CITY OF CONWAY, ARKANSAS HISTORIC DISTRICT COMMISSION

February 22, 2021 · 5:30pm

H.H. Bumpers House Exterior Modification

931 Center Street - Asa P. Robinson Historic District

SITE PLAN

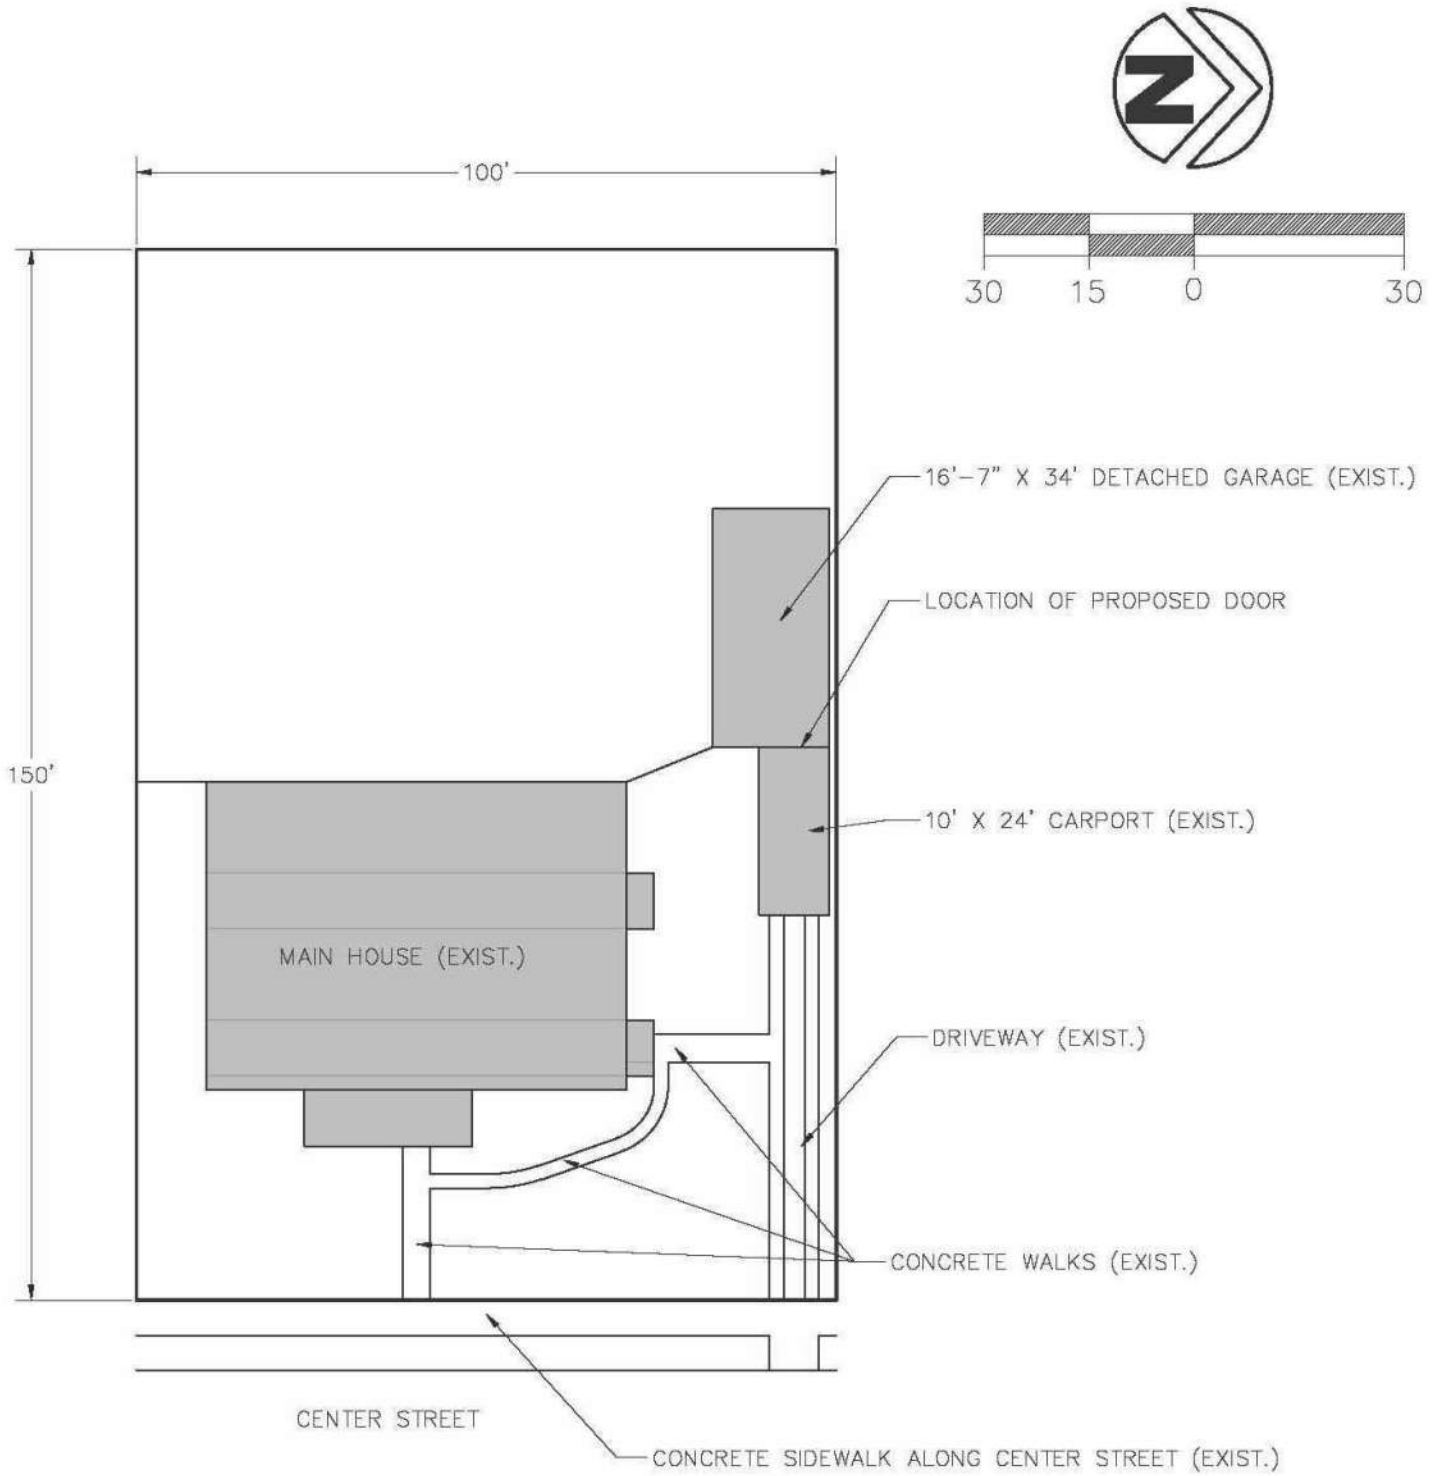
The applicant is proposing a wooden hinged bi-fold garage door to enclose the existing garage. The design is appropriate to the structure. Consider placing the bracing on the exterior of door to provide visual character (if technically feasible with the hinge mechanisms). Consider staining the door with a contrasting dark stain in lieu of painting (either option is acceptable).

Staff recommends approval of the exterior modification.

II.A

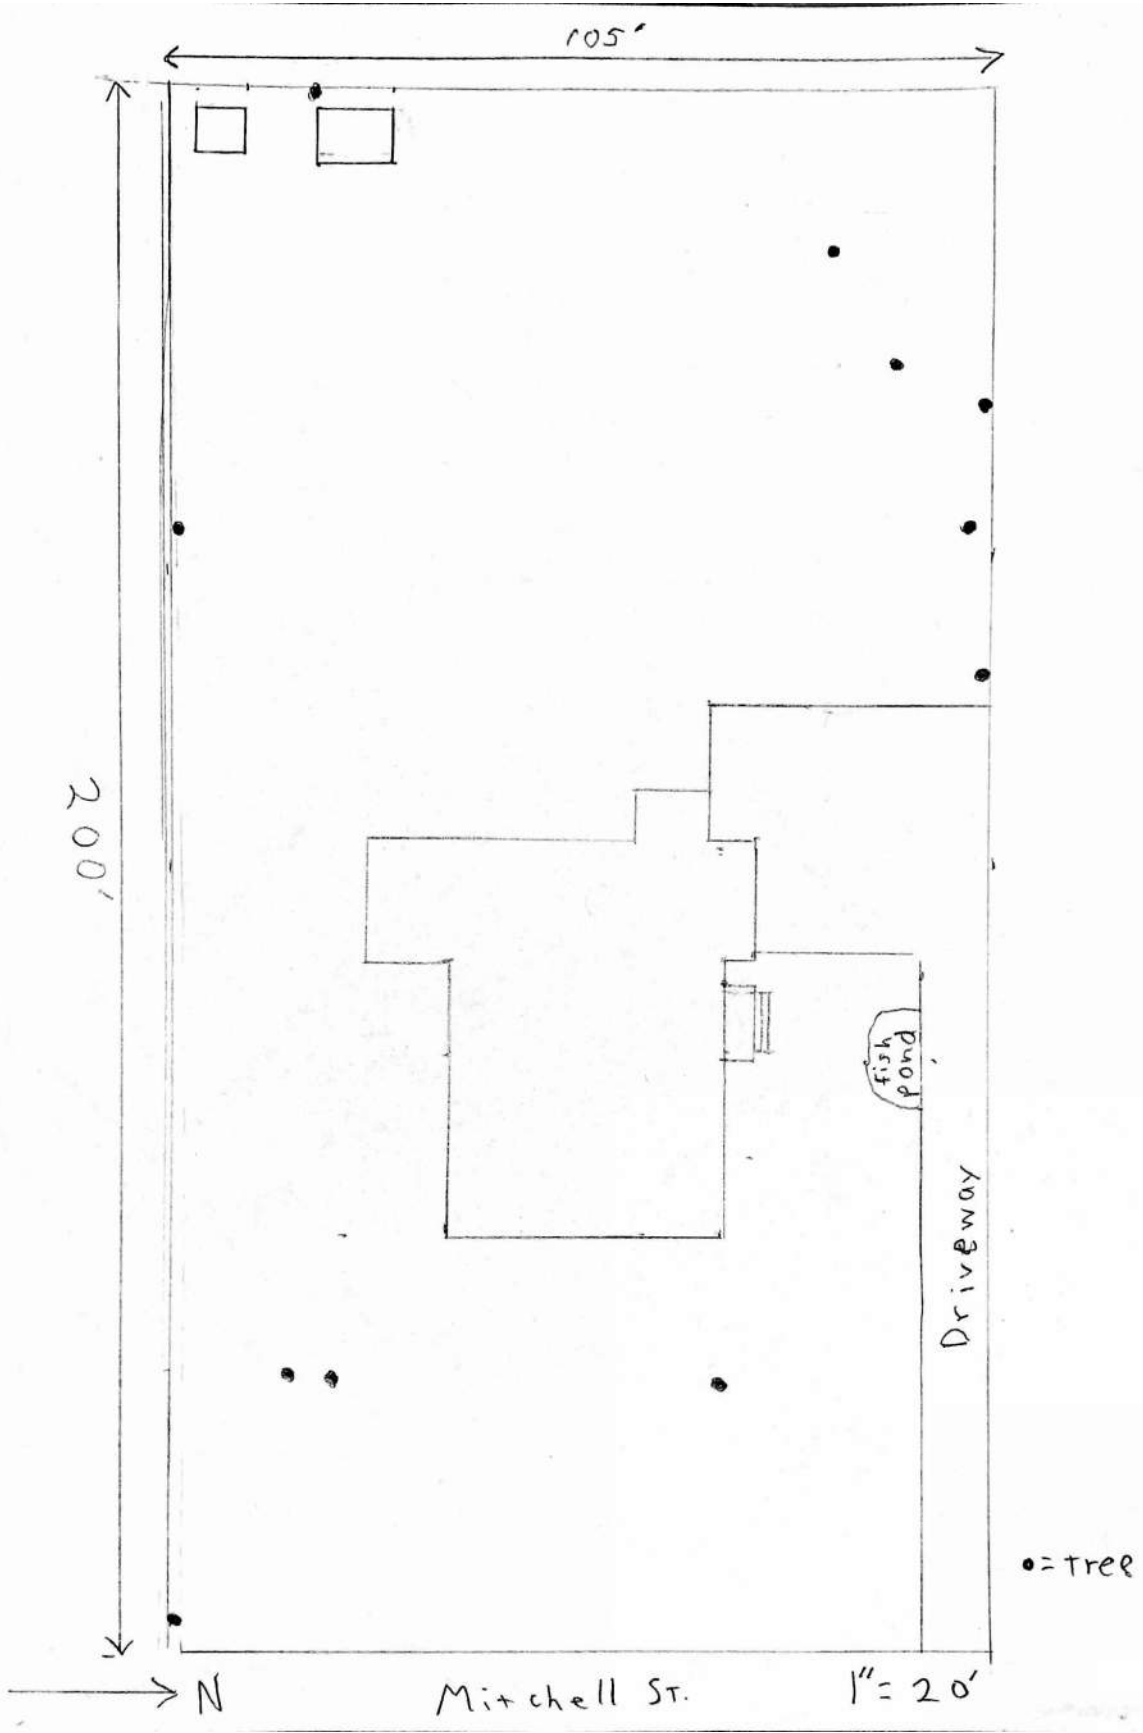
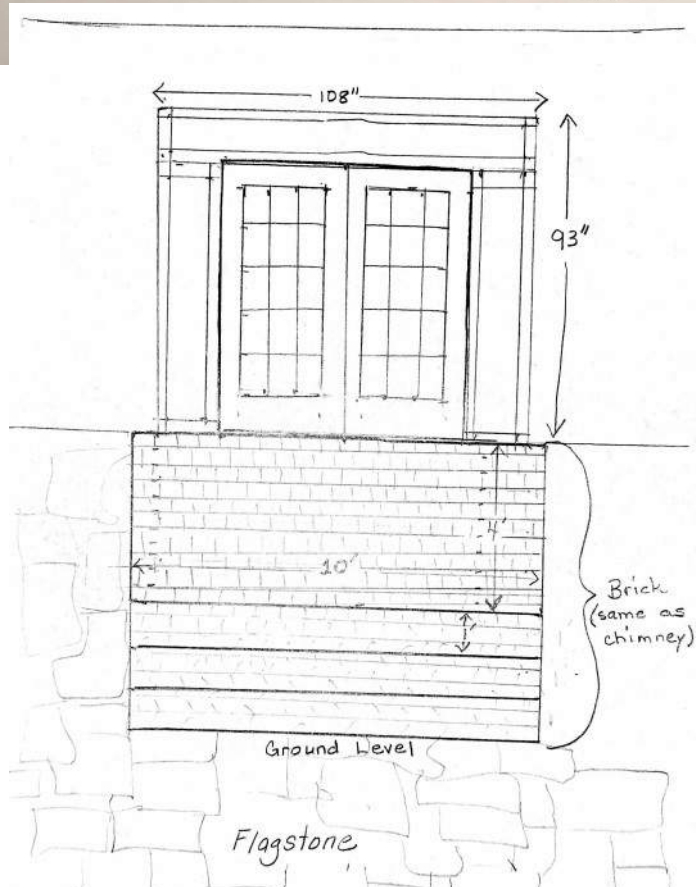
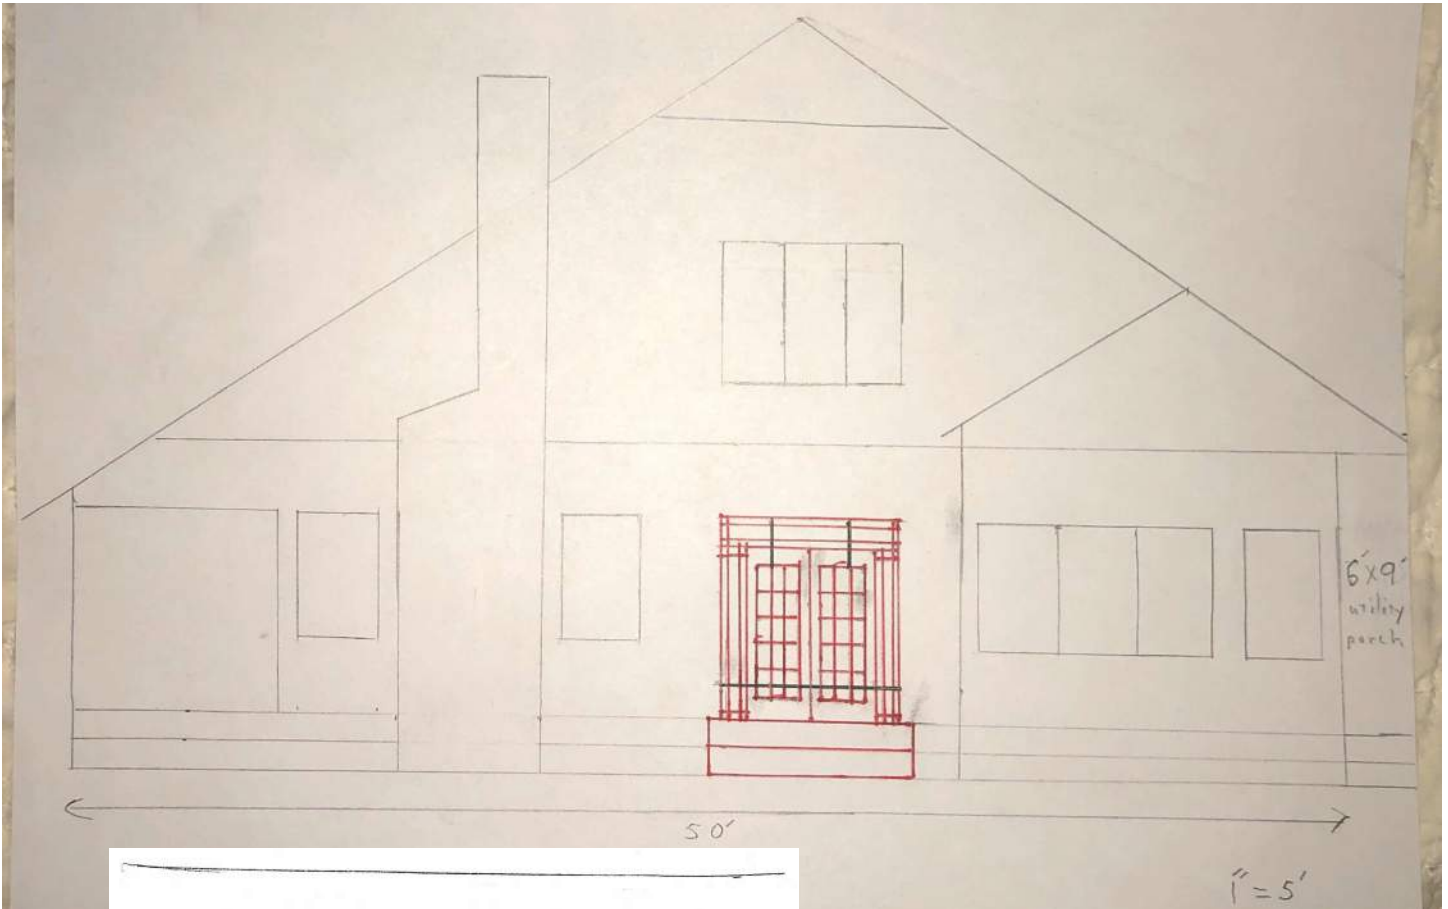
The alteration will be a conjectural element added on to the house, but there is precedent for similar patio entries. To maintain consistency in design, wide trim matching existing style of window trim on the opening should be used to surround the overall opening for the new entry.

The landing for the entry will use, in part, brick salvaged from repair of the chimney and brick to match. Recommend considering the addition of an arbor to overhand the entry with a tie in to columns matching the front porch.

Railings for the entry should match the railings for the front porch.

1. Require wide trim matching the existing style of window trim on the opening for the overall entry.
2. Railings for the entry should match the front porch in style and construction.

1. Consider adding an arbor to overhand the landing for the entry with columns to match the front porch.

1 SITE PLAN
1" = 10'-0"

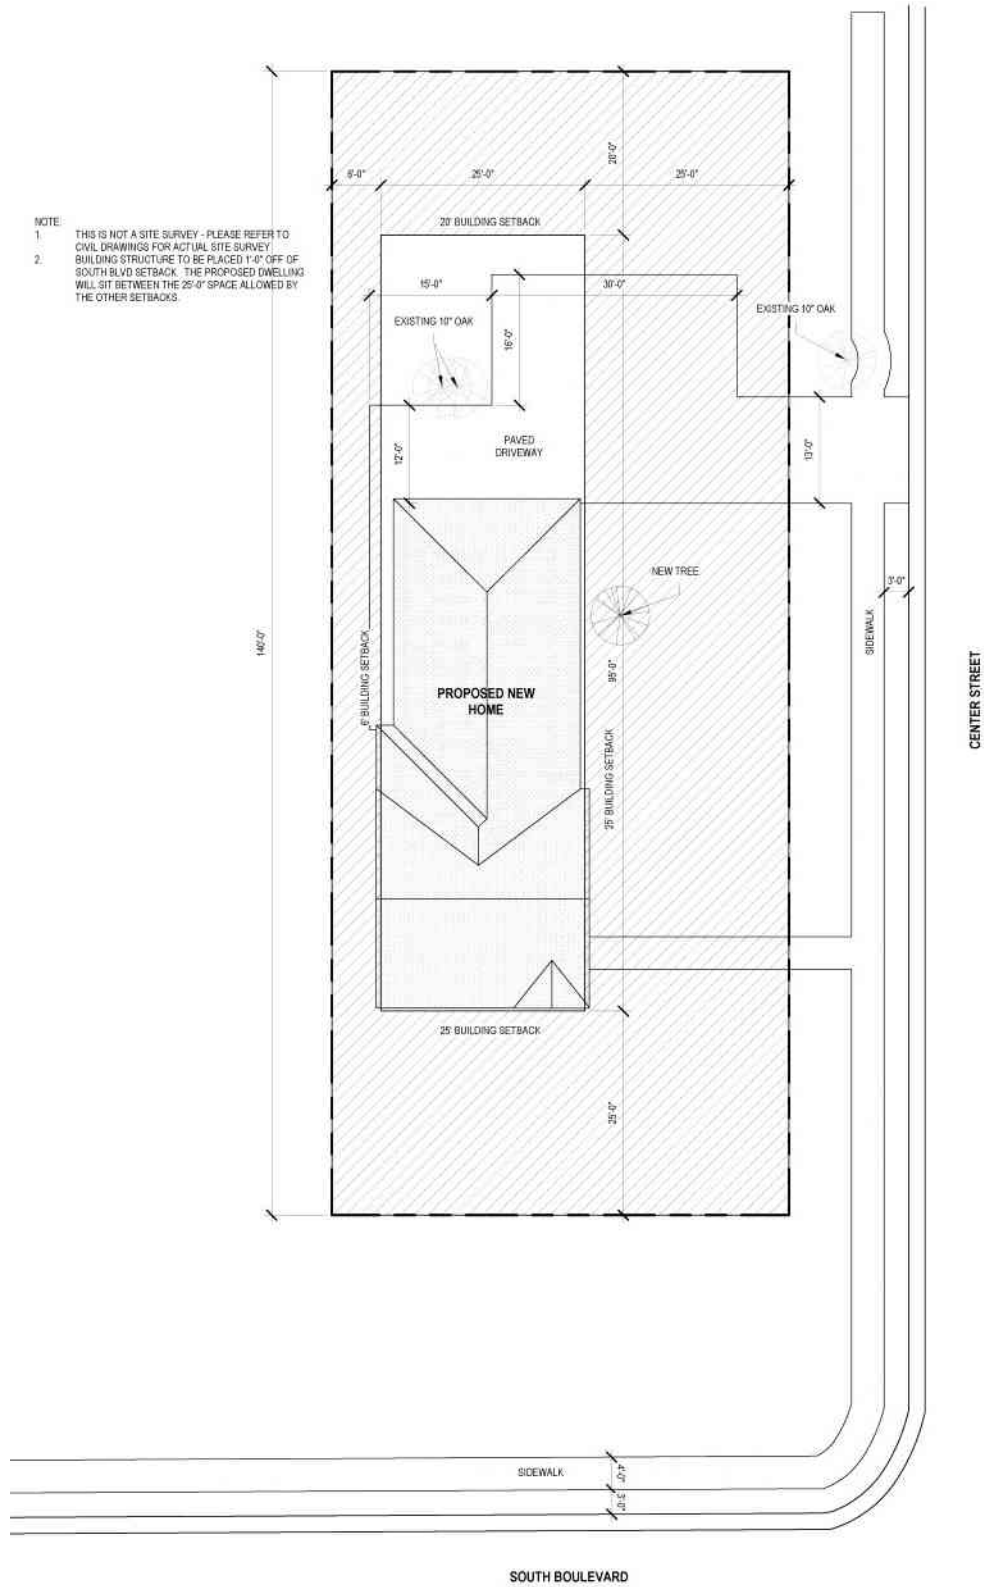
Setbacks and Spacing. Front setbacks are allowed within a range of 85% to 115% of the average front setback of the area. The average setback from the property line for the South Blvd frontage is 15.5'. The average setback from the property line for the Center St frontage is 20.' The included drawings indicate a setback of 25' for both frontages. The other proposed setbacks conform to the zoning requirements.

The proposed setbacks and spacing will need to be altered to meet requirements. The South Blvd frontage setback should be between 13'-18'. The Center St frontage should be between 17'-23'.

The applicant has proposed two parking alternatives. One with parking at the rear of the structure and one with parking at the front of the structure. Front yard parking cannot be approved per the requirements of the overlay district. The rear parking area is proposed with a 13' driveway and multiple parking pads. Recommend requiring the driveway be limited to 12' with a smaller redesigned parking pad.

There are no existing sidewalks on the site. The applicant is proposing 4' sidewalks. A 5' sidewalk with a 6.5' greenspace setback is required along each frontage. The proposed walk should connect to both entries to the porch.

The existing driveway proposal would imperil two large existing oak trees. The parking area and house should be moved to avoid encroaching on the drip line of these trees to the greatest extent possible. The planting of one canopy trees in the front yard is required. The planting of three canopy trees along the Center St frontage is required. The existing large oak along Center Street should be preserved.

1. Permit up to a 12' concrete driveway with a smaller redesigned parking pad.
2. Setback for the South Blvd frontage shall be between 13'-18'.
3. Setback for the Center St frontage shall be between 17'-23'.

4. Sidewalks are required along both frontages (5' sidewalk at least 6.5' from the back of curb).
5. The proposed walkway should connect to porch entries on both street frontages.

6. Planting of 1 canopy trees along the South Blvd frontage is required.
7. Planting of 3 canopy trees along the Center St frontage is required (reflects tree credit for the existing tree, which must be preserved).

6 EAST ELEVATION
1/4" = 1'-0"

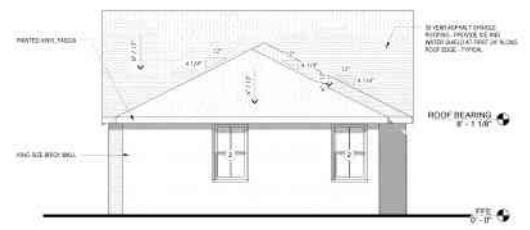
The front façade will be composed of 37% windows and openings which, based on the design, appears to be appropriate. The Center St façade will be composed of 23%, which rests just under the required 25%. Recommend requiring a small attic vent along this façade. See examples to the right. Additionally, recommend requiring at least one additional window on the west side façade within the living room (near front of house) as well as an attic vent.

An open front porch with a 6'-10' depth is proposed. The proposed vinyl windows are appropriate but should be of 1 over 1 design.

Roof forms and materials are appropriate. The applicant is proposing varying roof pitching, all which are appropriate. Recommend considering use of rafter tail style construction as this would add considerable character to the design.

8. Require a small attic vent on the east and west facades.
9. Require at least 1 additional window along the west façade in the living room.
10. Require windows to be true divided lights or 1 over 1 if not true divided light.

11. Require fascia and soffits to be finished with wood or wood equivalent construction (Hardieboard).
12. HVAC equipment be placed in a manner to minimize its visibility from the street.

1. Consider requiring use of exposed rafter tail style construction.

MASTER PLAN COMPLETE

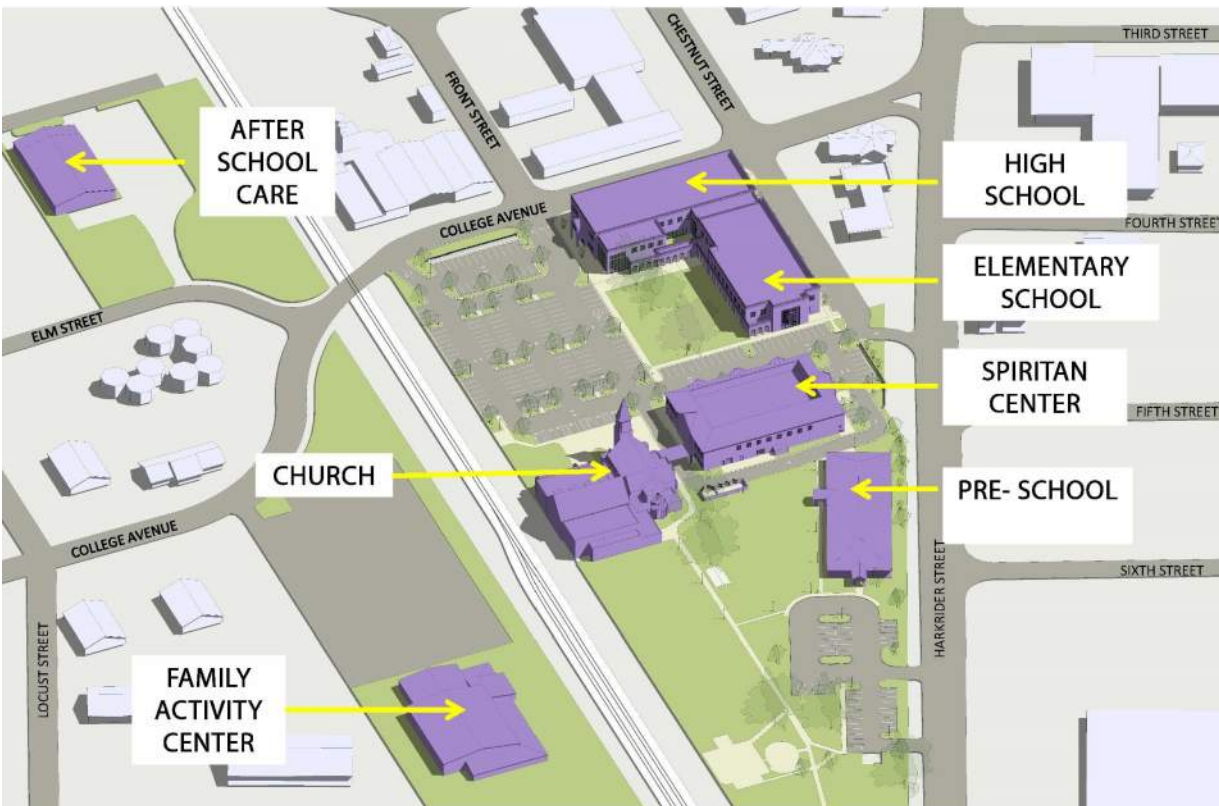
There are areas of the structure that are proposed to be clad in metal or have the use of metal screening. Based on the site's master plan these areas will be removed from public view with the future elementary school addition to the proposed structure.

1. Require brick instead of stucco within all public entries.
2. Recommend requiring additional plantings to help screen any public view of areas that will be clad in metal prior to construction of the elementary addition.
3. Screen all rooftop equipment.
4. Coordinate any necessary changes to the streetscape to match city standards for downtown with Conway Corporation and Conway Transportation.
5. Correction of the above conditions to be handled at the time of Development Review. The COA will be issued following Development Review Approval.
